BRRTS ID No. 02-30-553765

Review Date: 07/27/2016

Site Name: Holiday Village Coin Laundry

Title: Holiday Village Coin Laundry/0230553765/07272016/Radonaway RP145 Blower and outdoor switch

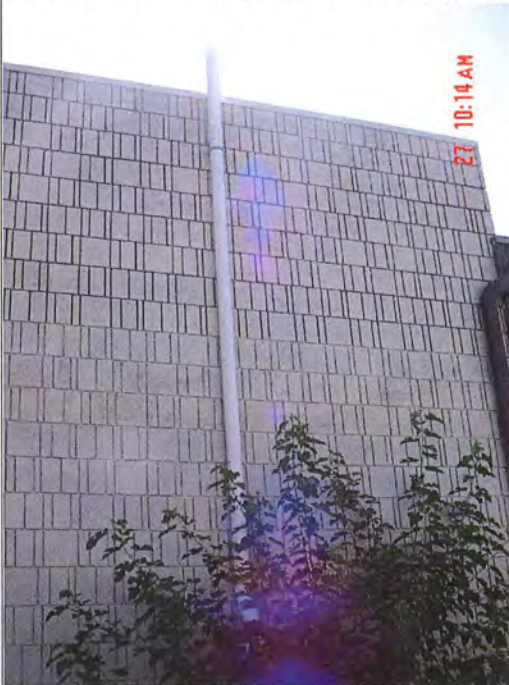
No** – Describe any follow up needed: System was not operating and requires maintenance. Fan was not running.

- Yes
- No – Describe what's not in compliance and the reasons for noncompliance:
Vapor mitigation system not operational. Fan not running.

- No
- Yes – Summarize the actions needed to return the site to compliance and identify who is responsible:
Vapor mitigation system need to be repaired and operated and maintained as as designed.
Electrical panel should clearly label dedicated circuit for vapor mitigation system.
